Re: GM Powertrain – Bedford Plant, IND 006036099
RCRA Corrective Action, East Plant Interim Measure
Proposed Grading Areas 3 and 4 Pre-Final Design Drawings
GM Powertrain Group, Bedford Indiana Facility
Bedford, Indiana

Please find enclosed the revised Pre-Final Design Drawings for proposed Grading Areas 3 and 4 for the East Plant Interim Measure at the GM Bedford Powertrain – Bedford Facility, 105 GM Drive, Bedford, Indiana. These drawings are being submitted pursuant to the Performance-Based Corrective Action Agreement between the U.S. EPA and General Motors (GM), signed March 20, 2001, and amended October 1, 2002.

GRADING AREAS 3 AND 4 FOR THE EAST PLANT AREA INTERIM MEASURE

Project Manager: J.M.	Reviewed By: J.D.	Date: JANUARY 2006
Scale: 1" = 100'	Project N°: 13968-00	Report N°: RAMA053 Drawing N°: C-03

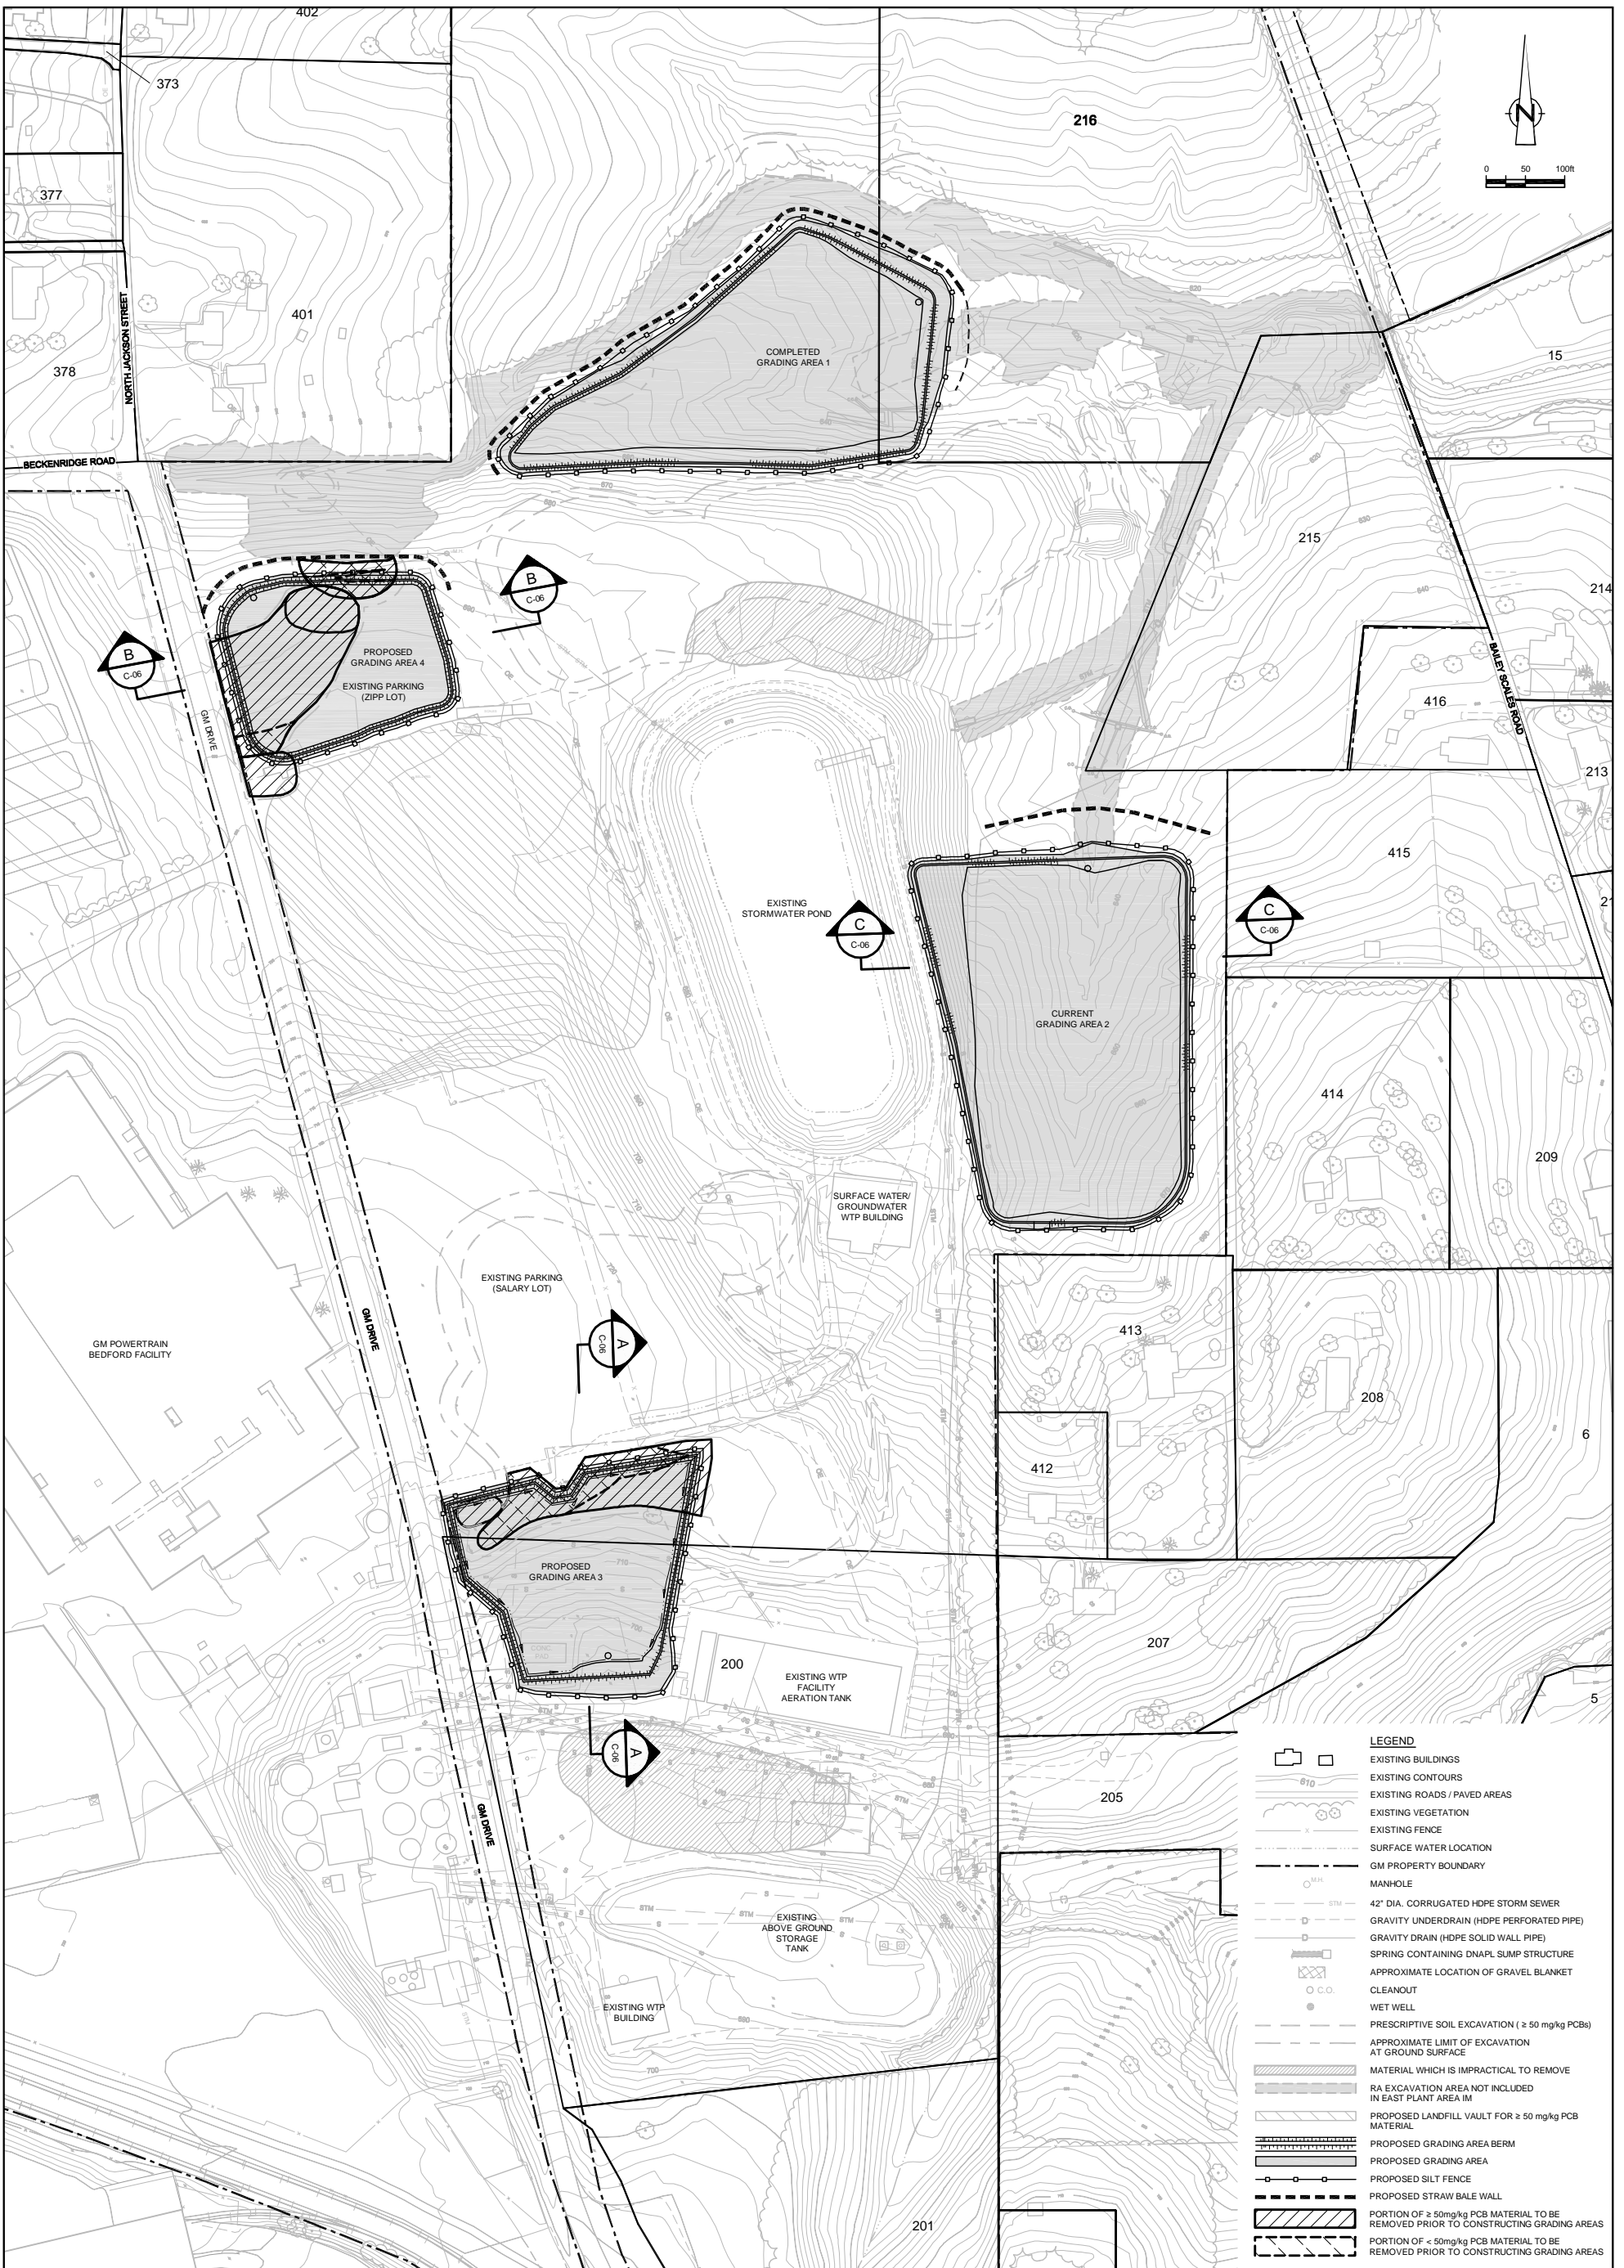
Nº	Revision	Date	Initial
1	REVISED PORTION OF PCB MATERIAL TO BE REMOVED PRIOR TO CONSTRUCTING GRADING AREA	JAN. 11, 2006	CRH
2	REVISED GRADING AREA 3 PERIMETER BERM	FEB. 6, 2006	CRH

Project Manager: J.M.	Reviewed By: J.D.	Date: JANUARY 2006
Scale: 1" = 30'	Project N ^o : 13968-00	Report N ^o : RAMA053
		Drawing N ^o : C-05

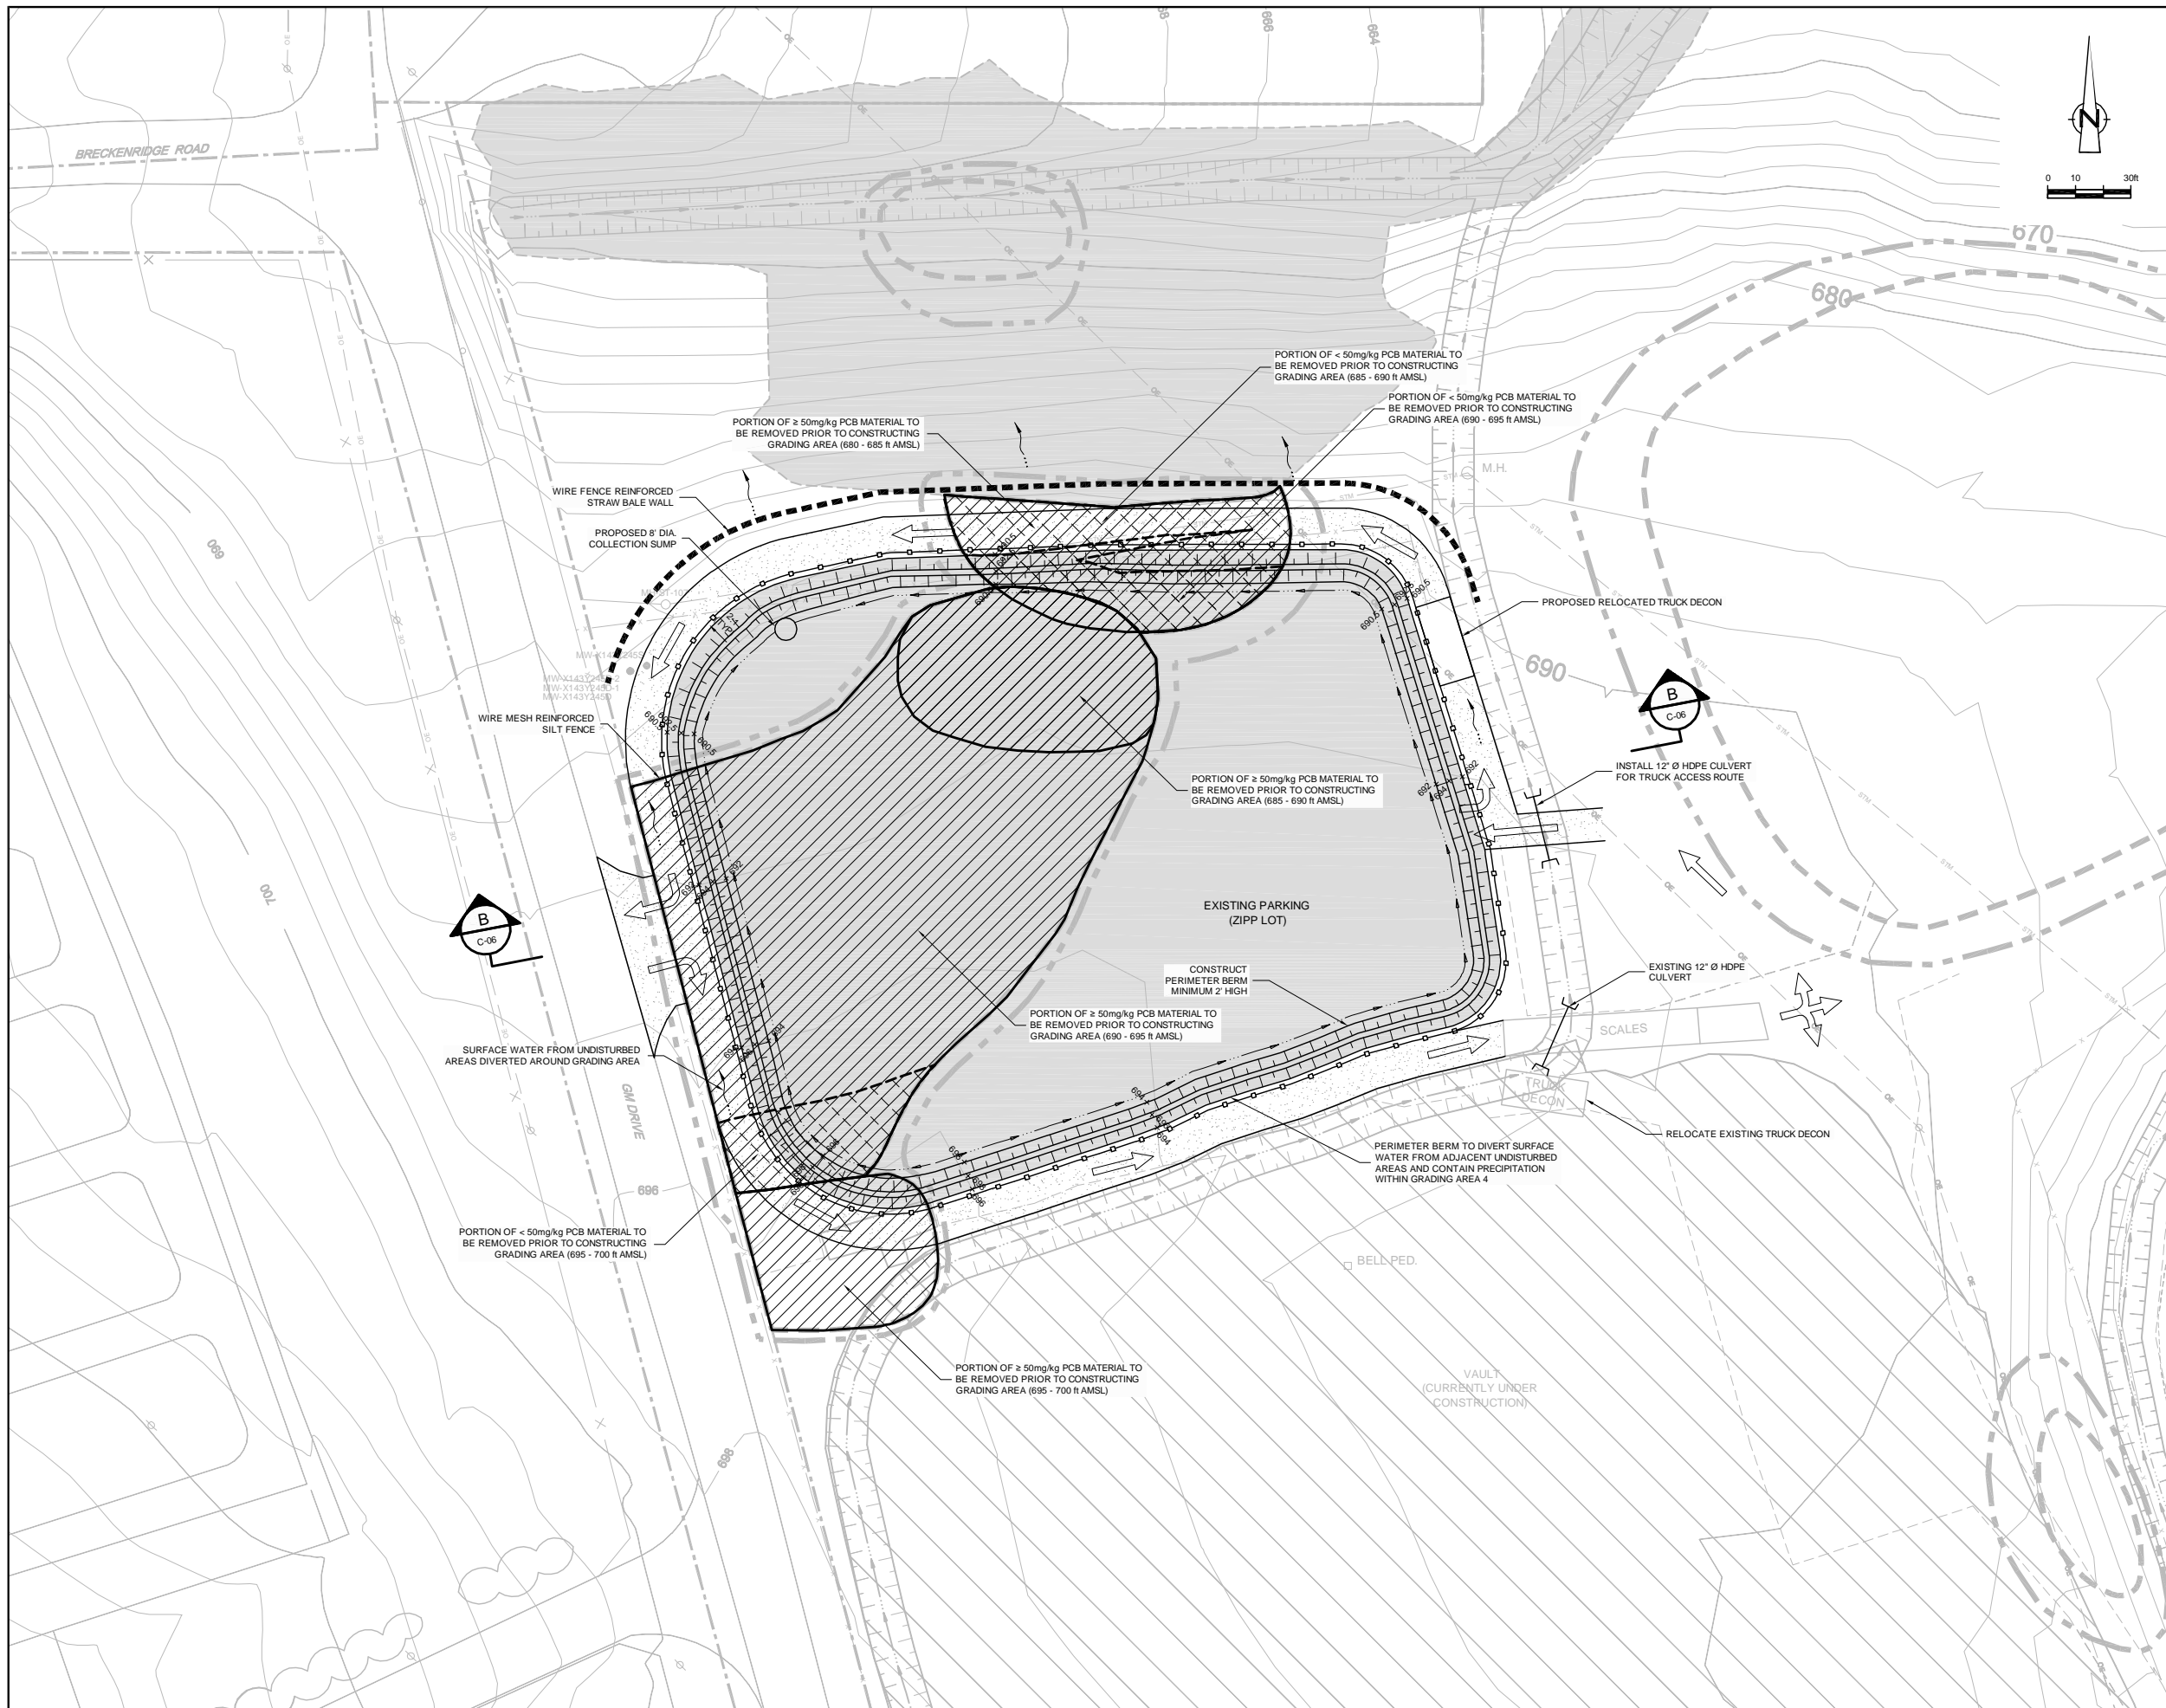
The proposed Grading Area 4 will be located on the current Zipp parking lot, directly north of the current vault location, as illustrated on Drawing C-05. Excavation of over 50 mg/kg PCB soils is required to be performed in this area prior to placing soil materials in this grading area. Soils beneath the Zipp parking lot are currently scheduled to be excavated as part of the second phase of over 50 mg/kg PCB excavation activities, but this excavation schedule can be adjusted to facilitate removal of these soil materials sooner (should Grading Area 3 become full prior to completion of the vault). Should this grading area be required, a new constructed temporary staging area for over 50 mg/kg PCB soils will be required, as the approximately 4,000 c.y. of material cannot be accommodated by the current temporary staging area located on AOI4. The limits of the over 50 mg/kg PCB soil materials excavation beneath the Zipp parking lot and Grading Area 4 are illustrated on Drawing C-05.

Grading Area 4 will be constructed to use as much of the current Zipp parking lot as possible, without preventing access to the rest of the East Plant Area (including the vault) for continued placement of both under 50 mg/kg PCB and over 50 mg/kg PCB soil materials. A traffic buffer zone (i.e. truck access road) has been designed around the perimeter of Grading Area 4. This truck access road will not be specifically constructed, but will utilize the outer limits of the current gravel surface over the Zipp parking lot. This will provide access for trucks from the current west gate off GM Drive to the weigh scales adjacent to the southeast corner of the Zipp parking lot. After unloading in the vault or one of the grading areas, all hauling vehicles would proceed around the other side of Grading Area 4 in a counter-clockwise direction to exit the East Plant Area. The traffic flow pattern is identified on the revised Drawing C-05.

NO	Revision	Date	Initial
1	REVISED PORTION OF PCB MATERIAL TO BE REMOVED PRIOR TO CONSTRUCTING GRADING AREA	JAN. 11, 2006	CRH

SECTION A GRADING AREA 3
 HOR. 1" = 40'
 VER. 1" = 20'

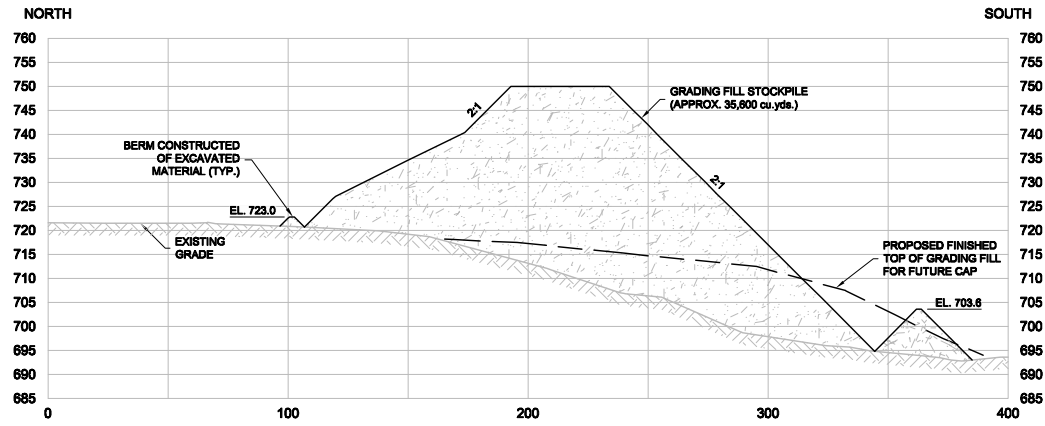
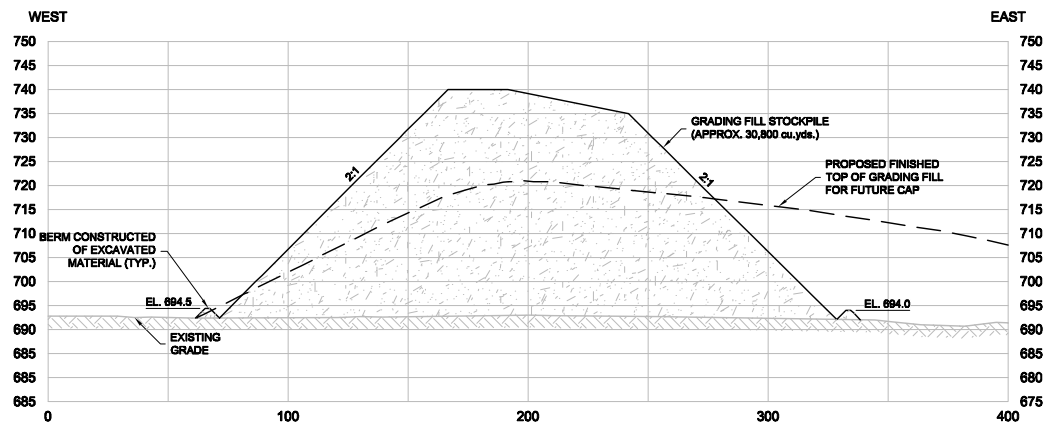
For Grading Area 3, the upper 15 feet of fill placement to achieve the peak only involves 2,000 c.y. or less, so the peak has been removed from the revised design to reduce the overall height. For Grading Area 4, the proposed height is similar to the final elevation of the adjacent vault (after capping) When it comes time to reshape the grading fill, the height of Grading Area 4 would be reduced by 20 feet along the cross-section shown on the drawings. The shape of Grading Area 4 is a little more rectangular, so the shape of the peak would be longer (i.e., not a point).

NO	Revision	Date	Initial
1	REVISED GRADING FILL STOCKPILE IN SECTION A	JAN. 11, 2006	CRH
2	REVISED GRADING FILL STOCKPILE AND PERIMETER BERM IN SECTION A	FEB. 6, 2006	CRH
